TC EC – Resolution on the
Technical Guideline
TG 4 Rev. 10

Technical Committee Electrical Characteristics (TC EC) – Decision from 18.03.2026

Supplement 1 to FGW TG 4 Rev. 10 Demands on Modelling and Validating Simulation Models of the Electrical Characteristics of Power Generating Units and Systems, Storage Systems as well as their Components

18.03.2026

Figure 1: Voltage curve for replicating an unsuccessful AR (Fig. B.6 [3])

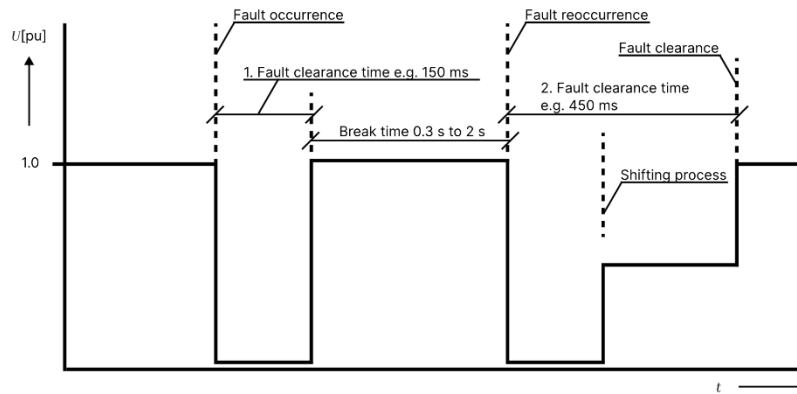
3.3.2.2 REPLICATION OF AN UNSUCCESSFUL AR IN ACCORDANCE WITH 9.2.2.3.2 TG 4 REV. 10 [2] (TYPE 2 UNITS)

The replication of an unsuccessful AR is based on the voltage curve shown in Figure 1.

If required by the applicable grid connection rule, unsuccessful AR tests must be carried out in accordance with Table 5. The grid impedance is calculated based on a grid short-circuit power equal to three times the design apparent power of the PGS, assuming an R/X ratio of 0,1.

Evaluation criteria: A positive result is achieved if each simulation runs without any error messages (simulation termination) and shows no signs of instability. Furthermore, the active and reactive power curves of all PGU units must return to their steady-state initial values following the short circuit. It must be evident that the applicable grid connection rule and the FNN guideline on grid-forming capabilities [1] have been correctly implemented, and these must be consistent with the manufacturer's other declarations.
